Mellieha

PC Number: PC 0046/13

Proposal: Partial Review of the Ta' Masrija Planning Policy (2006). The objectives set

Location: Site at Ta' Masrija, Mellieha.

Height Limitation Section D-D

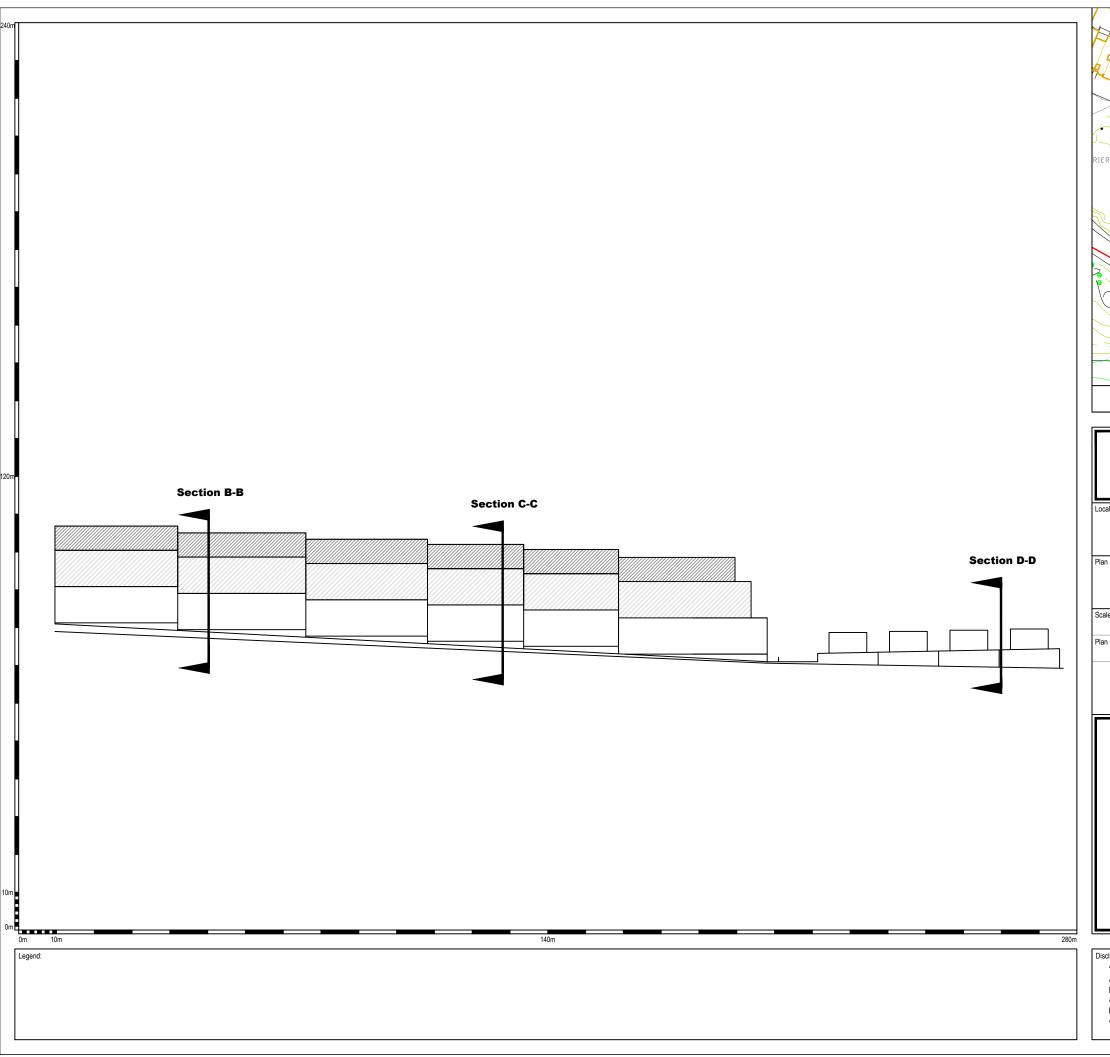
| (ii) | In view of the above amendments to the road layout, sectional drawing PC46/13/39G would have to be eliminated and replaced by a revised section reflecting the new layout — see doc. 50B. | |
